**To:** John Lopez, Amesbury Conservation Commission  
**From:** Gillian Davies, BSC Group, Inc.  
**Re:** Quimby Lane/206 Lion's Mouth Road

**Date:** January 14, 2013  
**Proj. No.**

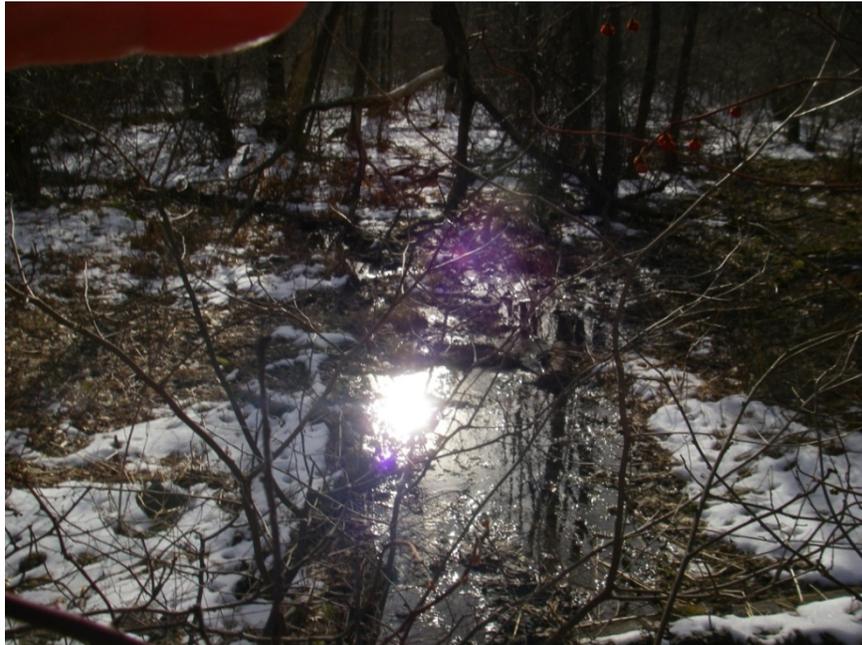
Although most of the pond was covered in ice and snow, this area was visible. Minimal sediment deposits were observed. Inspection is considered incomplete due to snow/ice coverage, and another inspection should be completed when ice and snow have melted.

Although most of the pond was covered in ice and snow, this area was visible. Minimal sediment deposits were observed. Inspection is considered incomplete due to snow/ice coverage, and another inspection should be completed when ice and snow have melted.
